TECHNICAL MEMORANDUM

Response to Comment Concerning Noise Levels on the Wellness Trail due to the Yorktown

A Solar Farm in the Town of Yorktown, NY

Reference: HMMH Project Number 312480.000

APPENDIX A. FIGURE SHOWING WELLNESS TRAIL

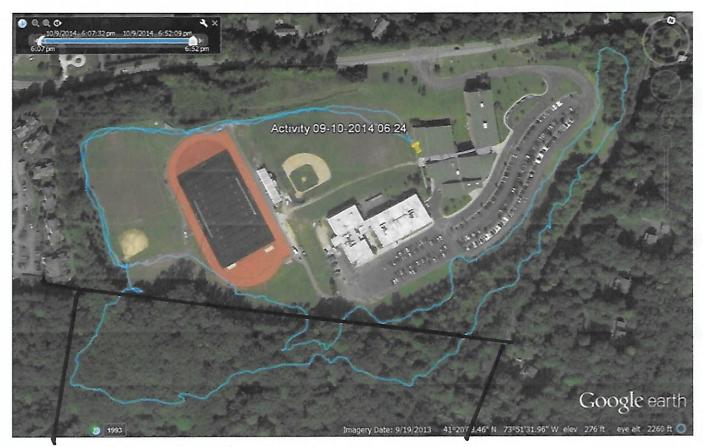
It is our understanding that the Town of Yorktown asked a question about noise levels on a "wellness trail" that is located on the grounds of the Putnam Valley Middle School and High School immediately to the north of the proposed Yorktown A Solar Farm. The attached image shows of the location of the trail as it had existed at some point in the past. We understand that the trail in no longer was located on the parcel of land under consideration for the proposed solar farm; that is, the trail is located entirely on school property.

While the layout of the relocated trail is not known, for the sake of this evaluation, it is assumed to be located along the property line between the school and the proposed project. As shown in Figure 1 of the July 25th Technical Memorandum, maximum continuous noise levels from the facility are expected to be 58 dBA L_{eq} along the property line of interest. Therefore, noise levels along the wellness trail are expected to meet the sound level limit in Section 300-81.5 G (7) of the Town of Yorktown, Code of Ordinances.
